COUNCIL ASSESSMENT REPORT

Panel Reference	2016SYE087
DA Number	DA16/0994
LGA	Sutherland Shire Council
Proposed Development	Demolition of existing structures and extension to existing approved residential aged care facility
Street Address	Lot B, C DP 404838, Lot A DP 406146, Lot 1, 2 DP 408232, Lot 45, 46, 47 DP 6303 – 2, 2A & 4 Locksley Street and 31, 33, 35, 37 & 39 Sturt Road, Cronulla
Applicant/Owner	Pathways Property Group Pty Limited
Date of DA lodgement	2 August 2016
Number of Submissions	30
Recommendation	Refusal
Regional Development Criteria (Schedule 4A of the EP&A Act)	General Development over \$20 million
List of all relevant s79C(1)(a) matters	<ul style="list-style-type: none"> • State Environmental Planning Policy (Housing for Seniors of People with a Disability) 2004 (Seniors Housing SEPP) • Sutherland Shire Local Environmental Plan 2015 (SSLEP 2015) • Draft Sutherland Shire Development Control Plan 2015 (DSSDCP 2015)

Building Height – cl.40(4)

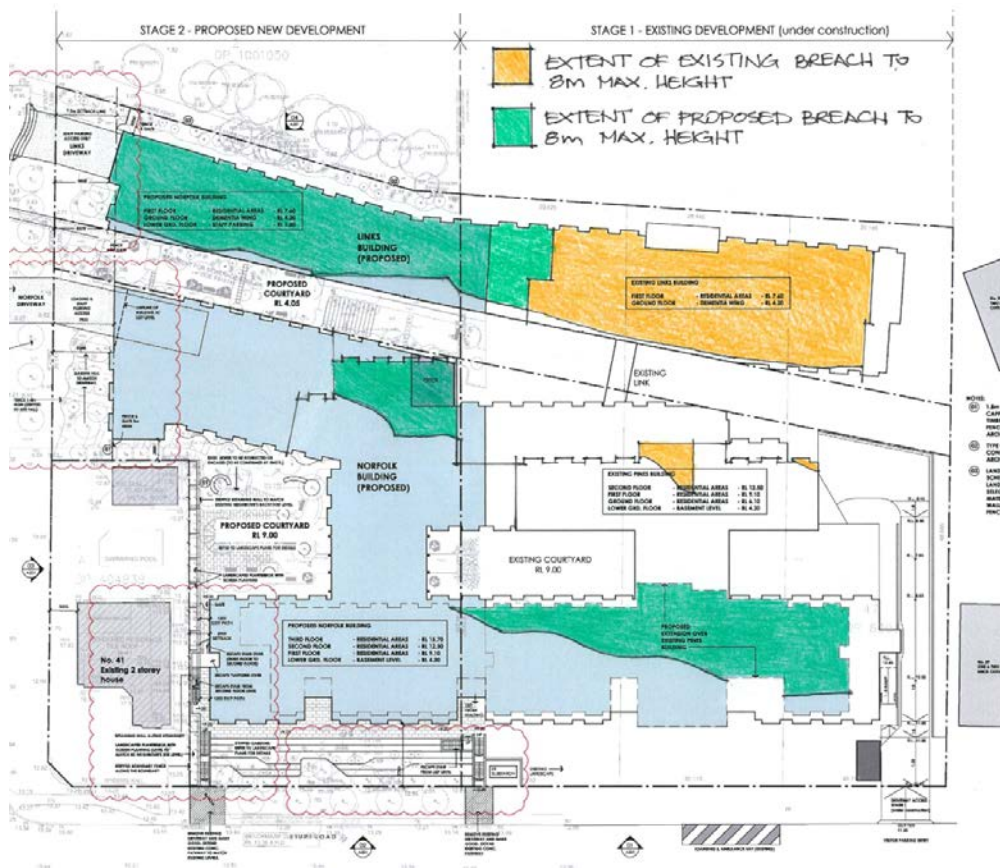
The proposal has a maximum height of 10.2m and the building located within the rear 25% of the site (the addition to the Links Building adjoining the northern boundary) is 3 storeys in height and also breaches the 8m maximum height attaining a height of 9.1m.

The fall of the site is noted as being a consideration in terms of the assessment of building height, although the actual fall of the site is closer to 11-12m as opposed to 15m. Notwithstanding, the existing development has demonstrated that a reasonable and compliant building form (for the most part) can be located on this site and result in a building mass and scale which has a relatively low-key presentation to the public domain and to adjoining properties. It is considered that the existing facility can be expanded by maintaining existing circulation, efficiencies and functional requirements of the facilities provided without necessarily breaching this standard further.

In terms of existing non-compliances to the 8m building height standard, they are generally concentrated to the rear 'Links Building' (refer to diagram below) with new works introducing an additional non-compliance along part of the building fronting Sturt Road.

As noted above, the existing facility is able to be logically extended without breaching the number of storeys development standard for the Links Building. Further, the lowest habitable floor level of the Links Building at RL4.20 is well above the 1% AEP flood level. The continuation of this floor level across the site satisfies flood requirements but does not necessarily mean that the maximum building height should be breached.

The continuation of a 3 storey 'wall' type building for the Links Building with little articulation and near the rear boundary is visually bulky and out of scale with the low density residential character of the area. The addition of the third storey along the Sturt Road frontage also has impacts on significant views currently obtained from dwellings along the southern side of Sturt Road. Views currently obtained are of distant water and city views which would largely be removed by the proposal. A view loss assessment has been carried out in detail below which concludes that the extent of view loss is unreasonable.

The applicant's written submission does not demonstrate that compliance with the building height development standard is unreasonable or unnecessary in the circumstances of the case. It also does not demonstrate sufficient environmental planning grounds to justify varying this development standard. The expansion of the existing development can be undertaken in a manner compatible with the function and utility of the existing facility without breaching the building height development standards. The proposed development is not in the public interest as the proposal fails to comply with the character objectives of the zone and fails to satisfy the typically accepted objectives for maintaining a maximum building height. The proposed variation does not raise any matters of State or regional environmental planning significance. In addition, there is a public benefit to maintain the height development standard in the circumstances of this case.

In conclusion, the variation to the height development standard does not satisfy all relevant parts of clause 4.6 and therefore the variation cannot be supported.
